STATE SIGNIFICANT DEVELOPMENT ASSESSMENT:
Bingo Recycling Pty Ltd
Mortdale Resource Recovery Facility
SSD 7421

Environmental Assessment Report
Section 89H of the
Environmental Planning and Assessment Act 1979

Figure 9: Swept Path Analysis - 19.6 m Truck-and-Dog Combination Entering and Medium Rigid Vehicle Exiting

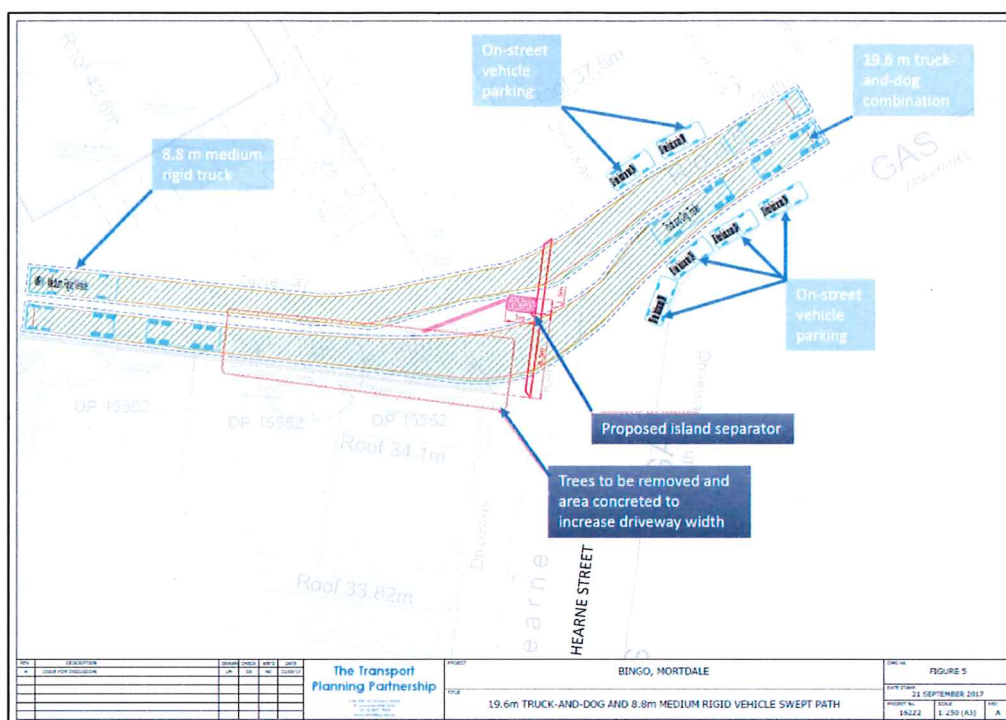
The Applicant's swept path analysis appears to provide adequate justification that the largest size of trucks proposed to access the site can maneuver unhindered in the event that 31 other trucks are stacked within the site. However, a swept path analysis of two 19 m + trucks entering and exiting the site at the same time was not provided and the Applicant has conceded that this movement would not be possible given the narrowness of Hearne Street and the location of on-street parking. Although only 7% of the trucks accessing the site would be 19 m + and the majority of these trucks would be transporting waste outside of peak hours, there would remain a possibility of this conflict occurring. To avoid potential safety issues or queuing in Hearne Street should two 19 m + vehicles reach the access / exit at the same time, the Department has recommended a condition of consent requiring the TCP to include provisions for requiring the traffic controller to stop the exiting truck to allow the entering truck to maneuver into the site unhindered.

Figure 11: Truck Stacking Plan and Semi-Trailer Swept Path Analysis

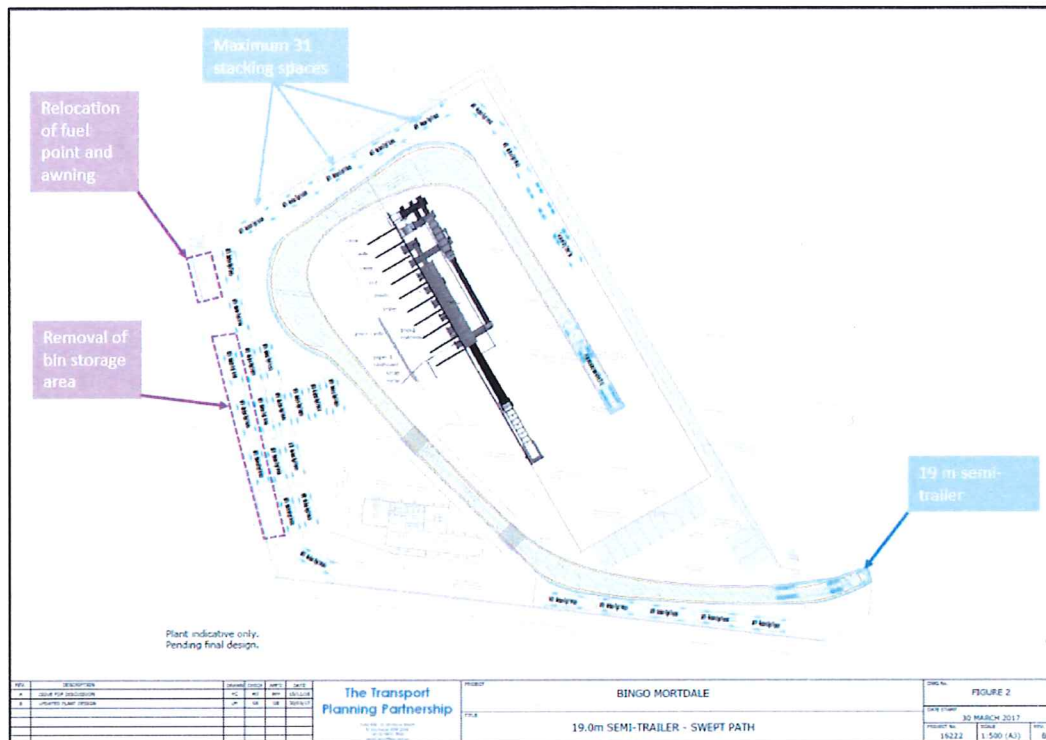
Council raised concerns that in the absence of a robust assessment including a truck stacking plan and a detailed swept path analysis, it was unclear if the size and layout of the facility would cater for the number of trucks accessing the site during peak periods based on the proposed processing volumes. Council also raised concerns that internal vehicle stacking would conflict with the required maneuvering of trucks picking up processed waste.

The Department also raised concerns that the TIA did not provide enough information to justify the site as designed was suitable for the proposed truck volumes to avoid queuing within the road or delays in processing. In particular, the Department required the Applicant to provide:

- a revised swept path analysis of all types of proposed trucks maneuvering unhindered throughout the site
- a swept path analysis of all combinations of trucks entering and exiting the site from and into the appropriate lane within Hearne Street in a forward direction
- a time-step analysis showing the maximum number of trucks that will be onsite during peak periods
- a vehicle 'stacking plan' indicating the proposed areas for trucks to wait (stack) onsite and the number of trucks that could be stacked onsite at one time without impacting the maneuvering of vehicles
- proposed traffic controls to avoid conflicts at the access and through the site.

To accommodate the movements and stacking of trucks, the Applicant removed the 'bin storage' area previously proposed adjacent to the western fence and relocated the fuel point further to the north. The Applicant's stacking plans indicated the site could cater for the stacking of a maximum of 31 trucks on site at any given period without hindering the maneuvering of semi-trailers or truck-dog-combinations through the site (see **Figure 11**).

Figure 12: Saturation of Truck Stacking During A-Typical Operations (avg. truck duration of 50 mins on site)

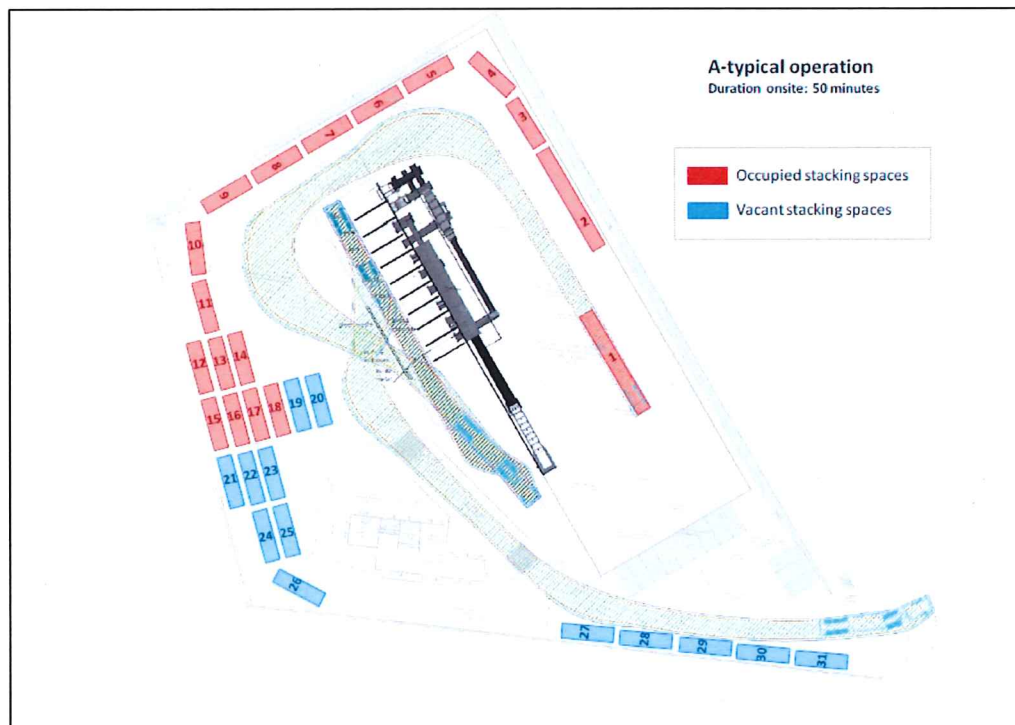
The time-step analysis and stacking plans appear to show that, even during a worst-case scenario in which trucks remain on the site for 50 minutes, there would be no queuing within Hearne Street. The Department agrees with Council that adequate measures and contingencies need to be in place to avoid queuing within Hearne Street during a number of situations. For instance, should a truck break down within the site or at the entrance, protocols must be in place to re-direct trucks to other facilities to avoid queuing. Such protocols would include contacting truck drivers remotely and traffic controllers directing trucks away from the facility. The Department has recommended a condition of consent requiring the preparation of a TMP and TCP detailing these and other measures to avoid any queuing within Hearne Street. A further condition has been recommended prohibiting any vehicles accessing the site from queuing or parking within Hearne Street. Should the facility operate within the confines of the mitigation measures provided by the Applicant and the recommended conditions of consent of the Department and Council, it is unlikely the development would compromise the safety and efficiency of Hearne Street.
